BENT GRASS EAST COMMERCIAL
11659 BENT GRASS MARKET VIEW
EL PASO COUNTY, CO
DEVELOPMENT PLAN

COVER SHEET

PCD File No. PPR2625

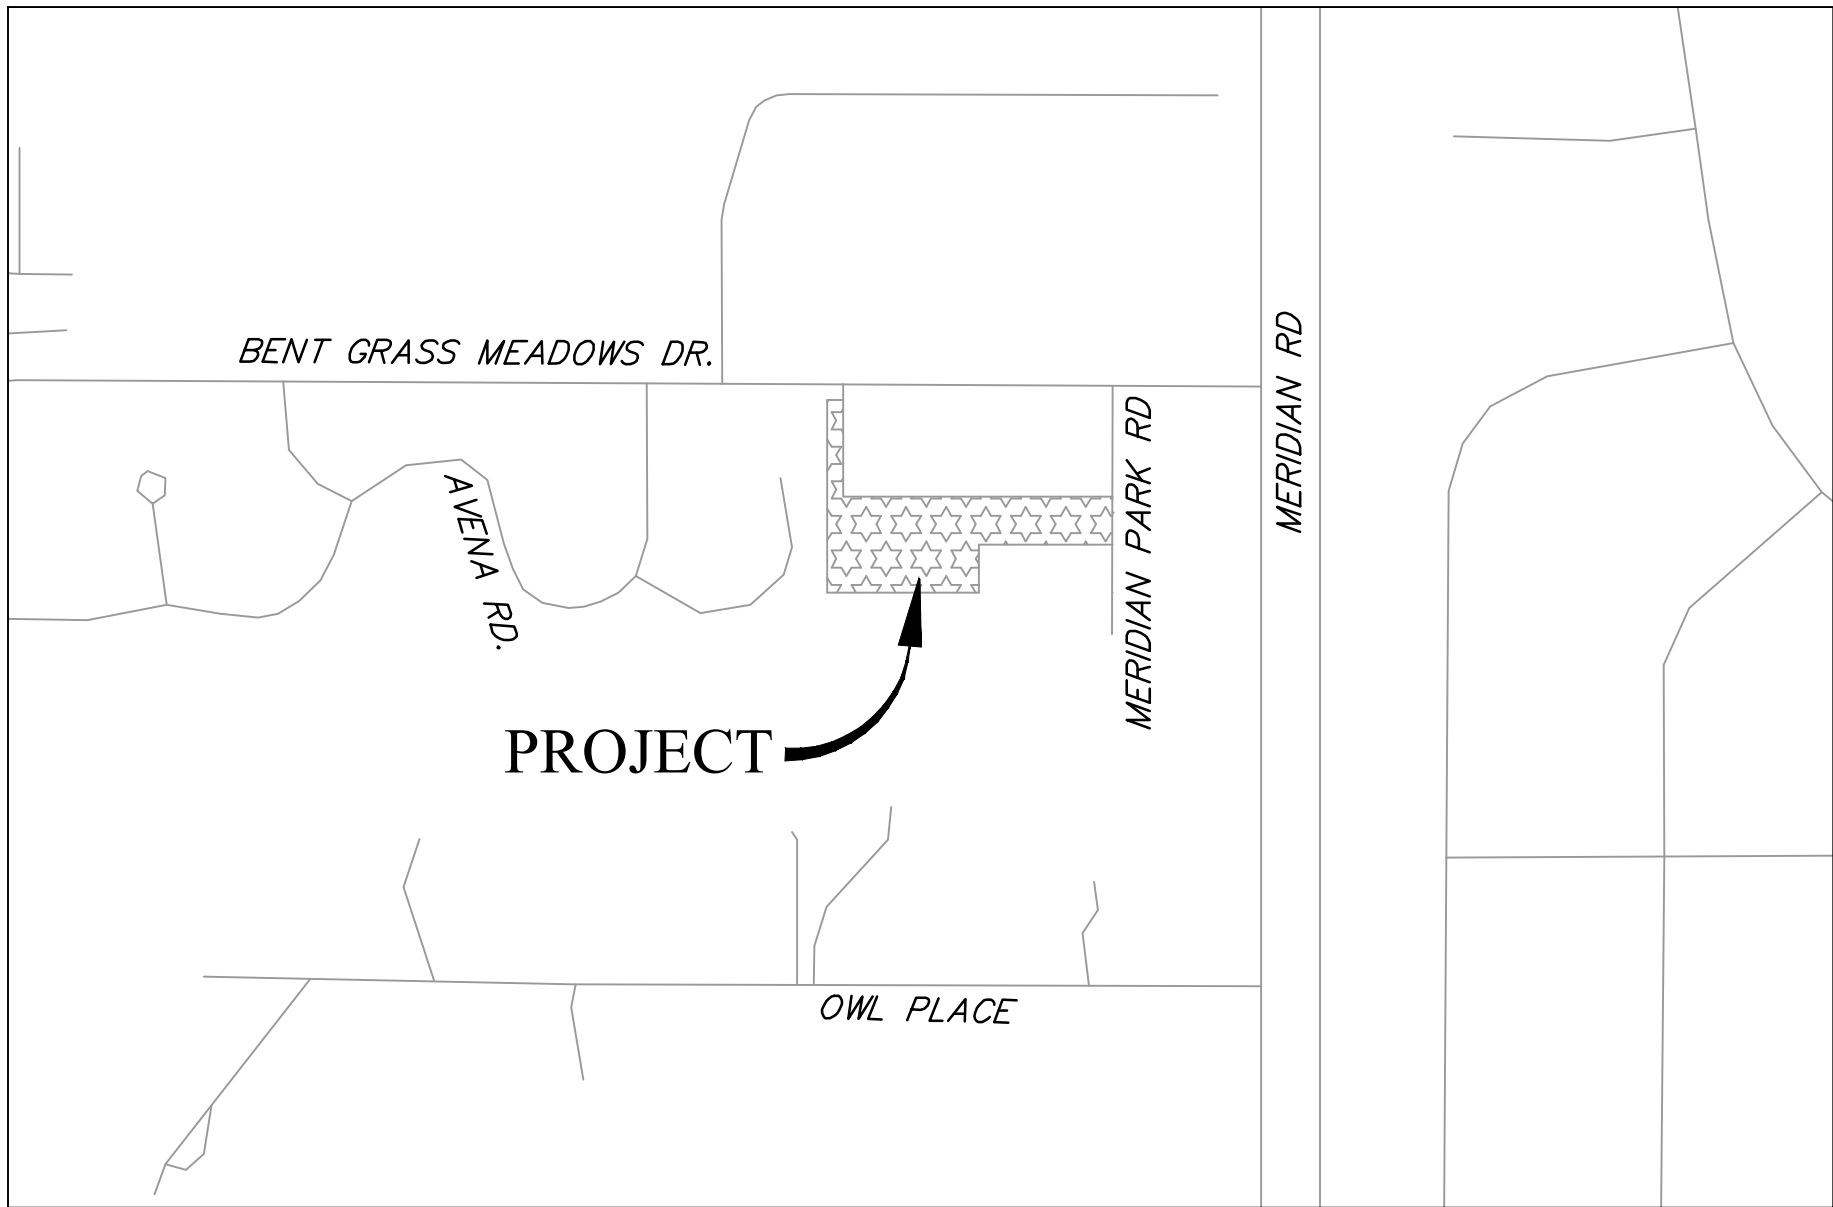
V1 Comment:
County

V1 Comment:
County; please be
specific.

SITE PLAN

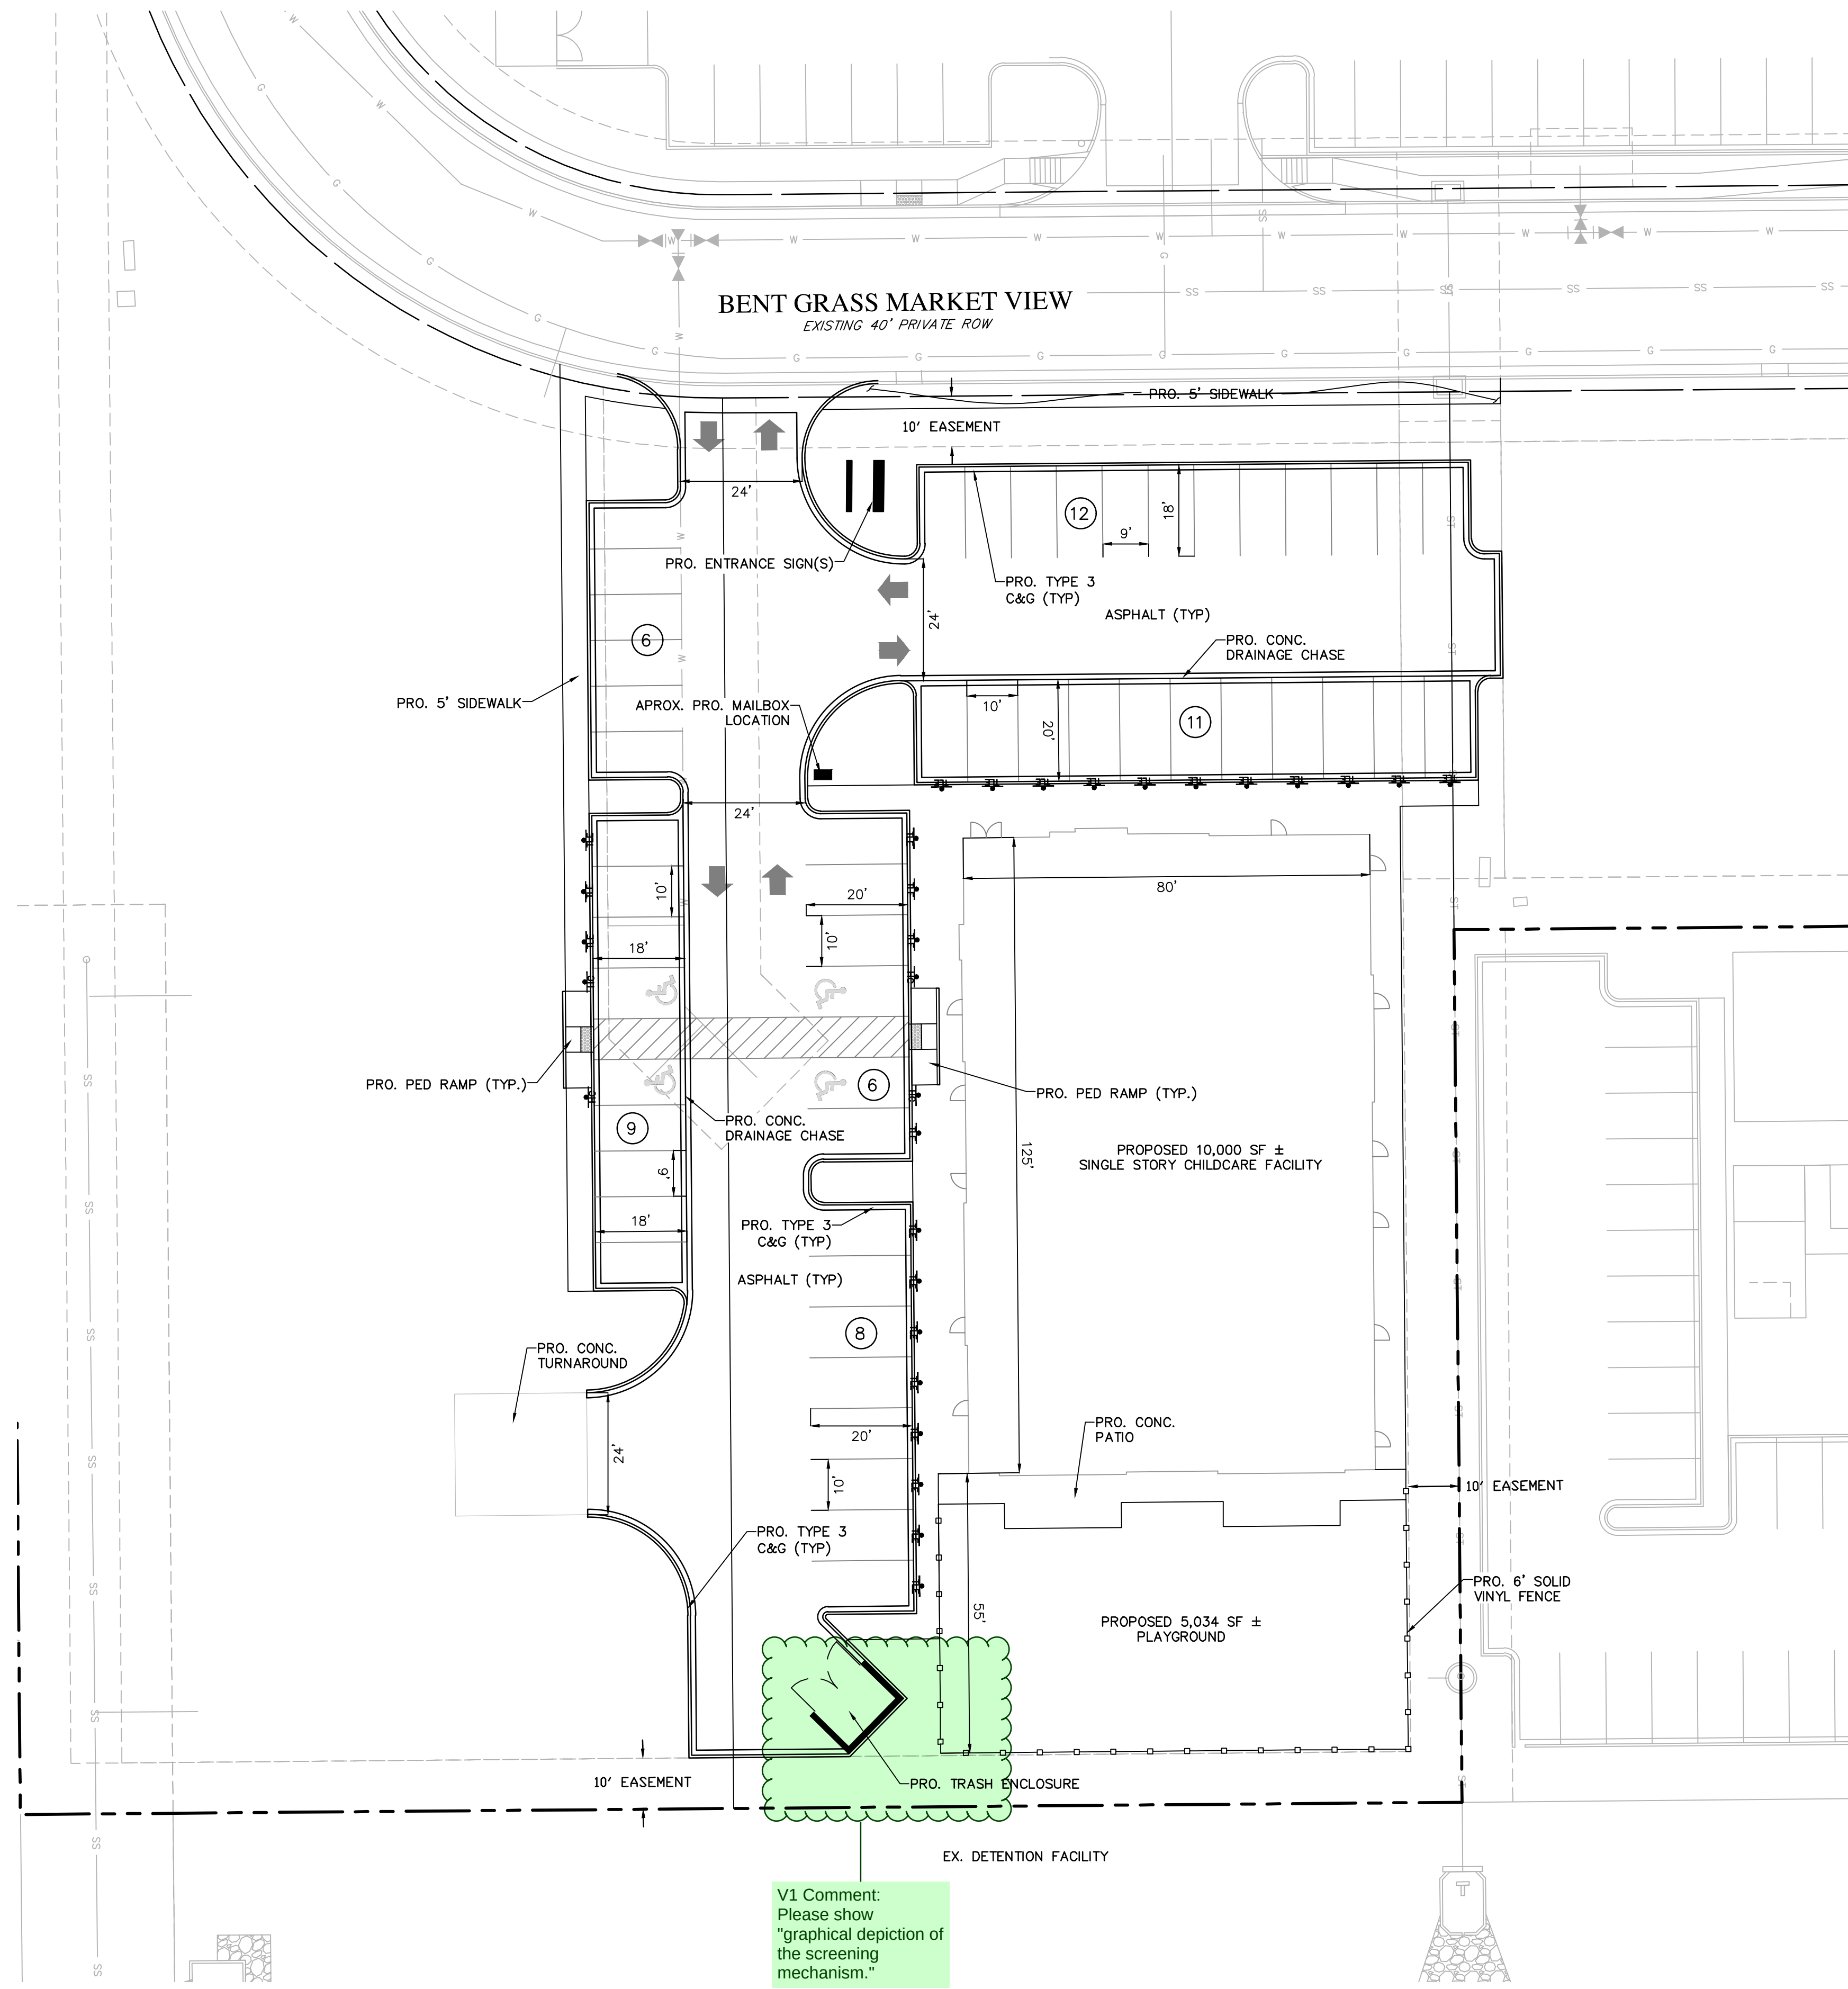
V1 Comment:

Please add:

V1 Comment:
Please show
"graphical depiction of
the screening
mechanism."
